AMENDMENTS TO THE DRAWINGS:

REMARKS

Fig. 8.

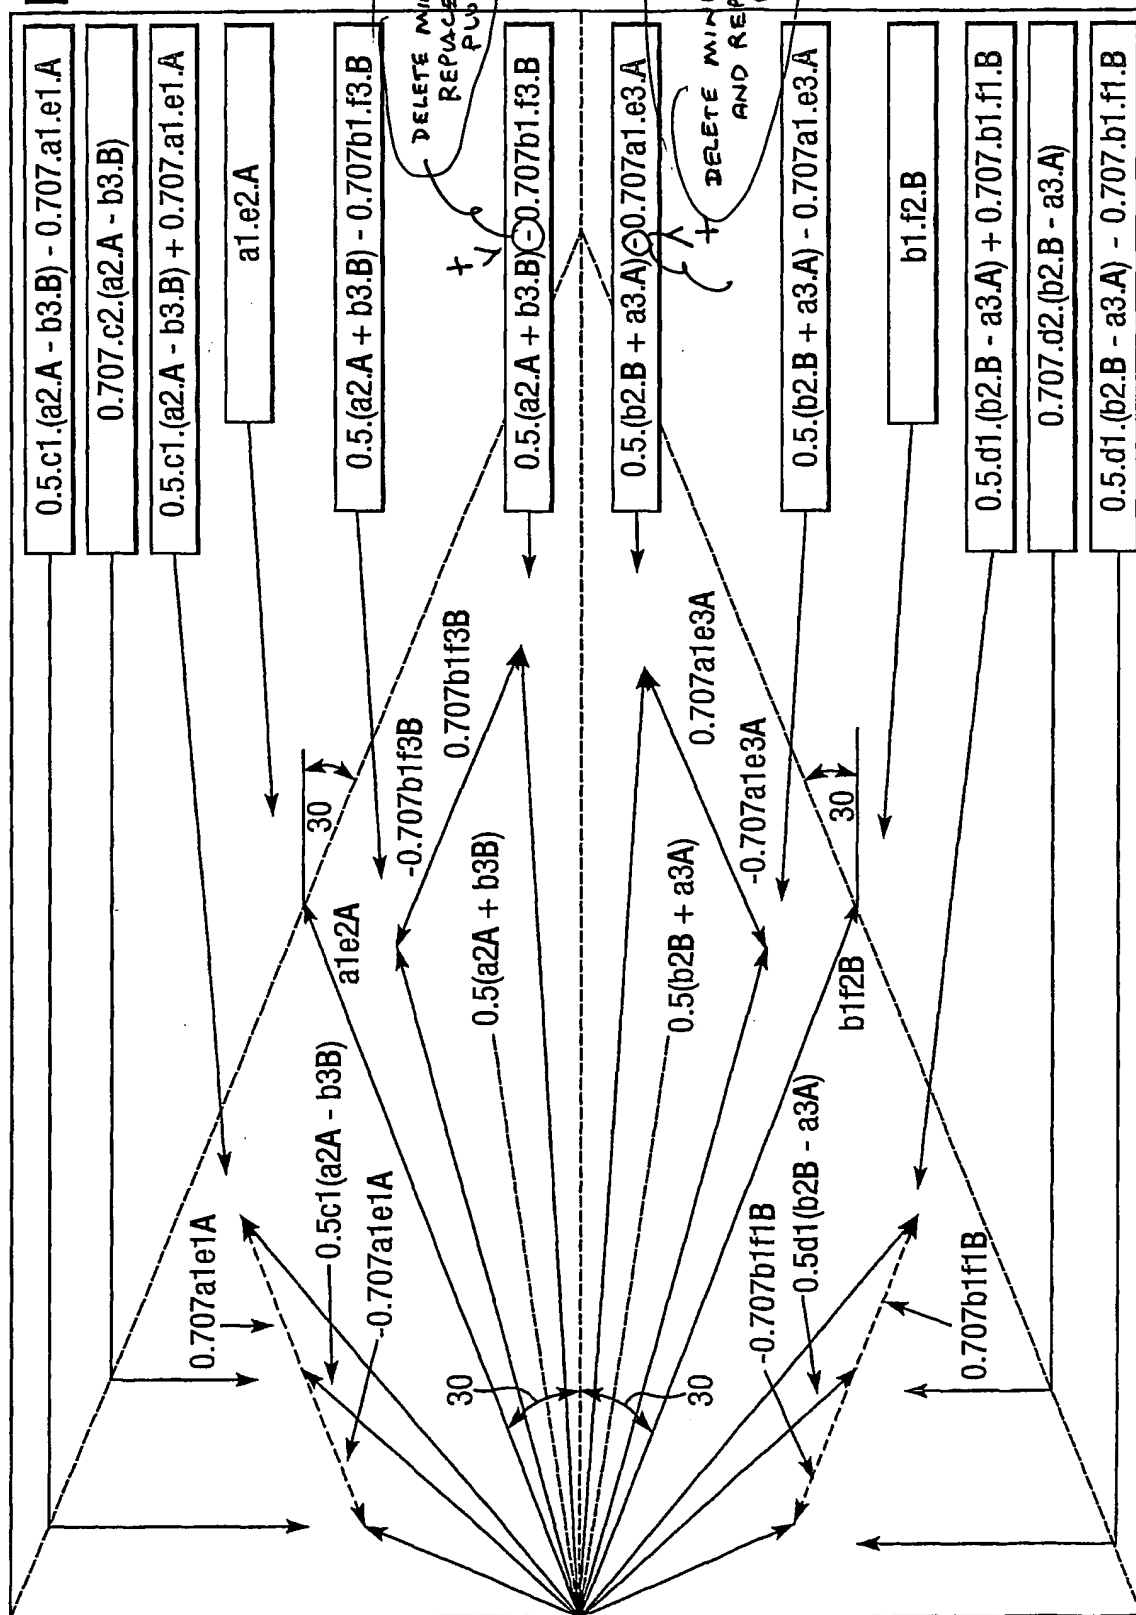
The attached drawing sheets include amended and marked-up versions of Figure 8. Figure 8 has been amended to change several minus (-) signs to plus (+) signs.

Figure 8 is amended in two instances to change minus signs ("-") to plus signs ("+"). This amendment is supported by vector diagrams (arrows indicating vectors in magnitude and direction) adjacent to the left side of the amended Figure 8 boxes, which show 0.707b1f3B being added to $0.5(a2A + b3B)$ and 0.707a1e3A being added to $0.5(b2B + a3A)$ respectively. Additional support for this amendment is found in the specification and figures.
